Title - Sujet Pump Replacement	
Solicitation No. - N° de l'invitation F1700-120202/A	Amendment No. - N° modif. 003
Client Reference No. - N° de référence du client	Date 2012-07-12
GETS Reference No. - N° de référence de SEAG PW-\$PWY-019-6717	
File No. - N° de dossier PWY-2-35021 (019)	CCC No./N° CCC - FMS No./N° VME
Solicitation Closes - L'invitation prend fin at - à 02:00 PM on - le 2012-07-19	Time Zone Fuseau horaire Pacific Daylight Saving Time PDT
F.O.B. - F.A.B. Plant-Usine: <input type="checkbox"/> Destination: <input checked="" type="checkbox"/> Other-Autre: <input type="checkbox"/>	
Address Enquiries to: - Adresser toutes questions à: Ngan, Ken (PWY)	Buyer Id - Id de l'acheteur pwy019
Telephone No. - N° de téléphone (604) 658-2755 ()	FAX No. - N° de FAX (604) 775-6633
Destination - of Goods, Services, and Construction: Destination - des biens, services et construction: DFO - Quinsam River Hatchery, Campbell River, B.C.

**Pump Replacement
Quinsam River Hatchery**

Solicitation: F1700-120202
Pump Replacement – Quinsam River Hatchery

Addendum No. 2

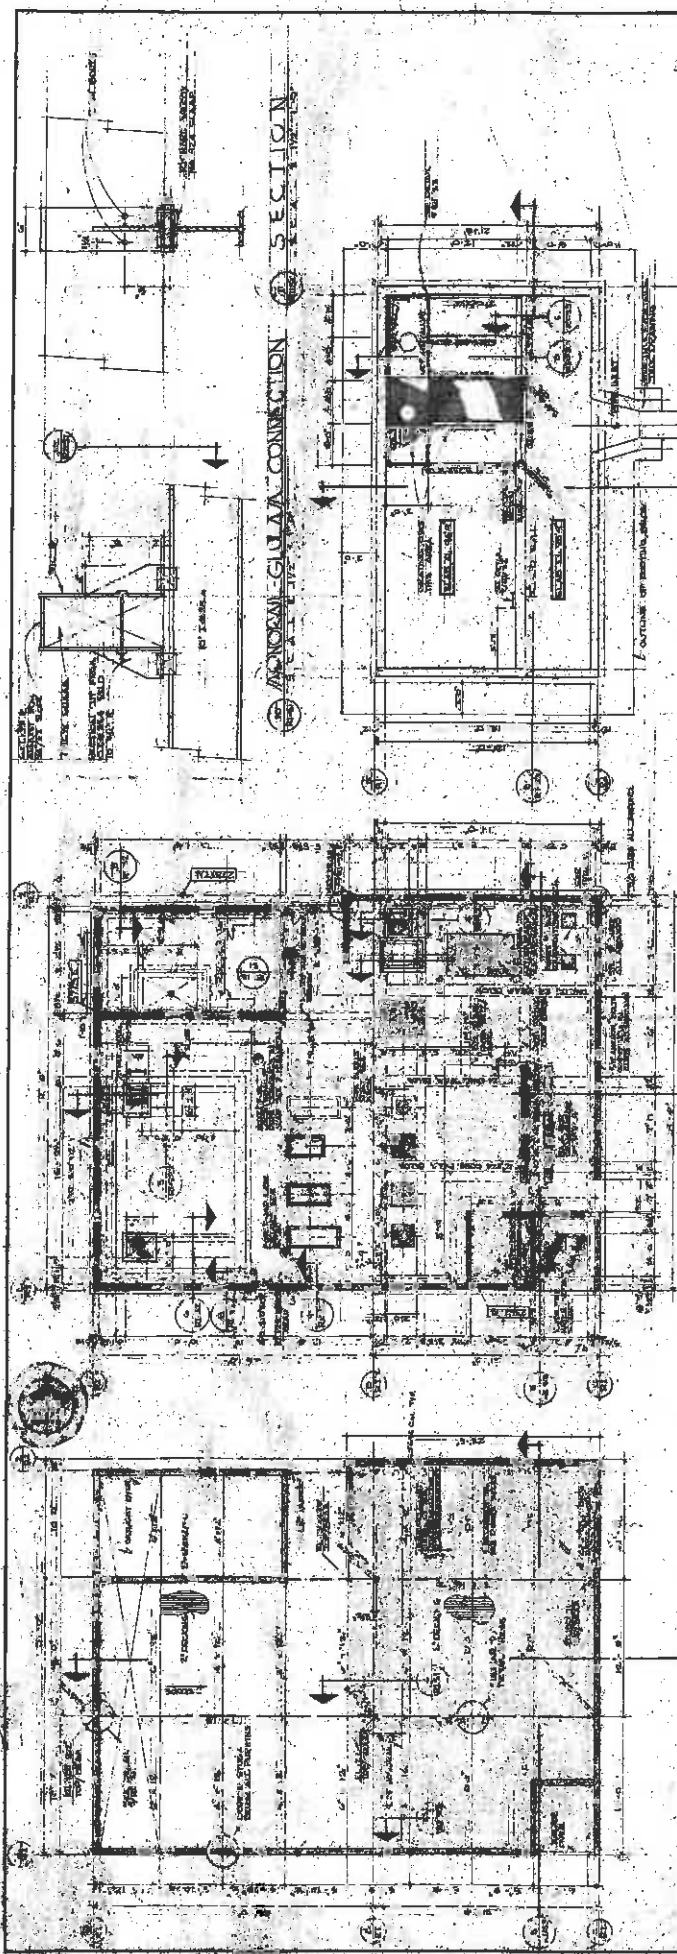
6. In reviewing Pump No. ASP 9, we noted that the required conditions of service would fit very neatly into our G-196- 3 x 4 x 10 H, MTX pump which is also an ANSI configuration.

Upon review of the documents provided, the proposed ANSIFLO pump is an approved equivalent for pump (ASP 8). From the information provide the proposed alternate meets the ANSI requirements for component and flow characteristics.

The lower efficiencies of the proposed pump make it an unacceptable substitution for pump (ASP 9).
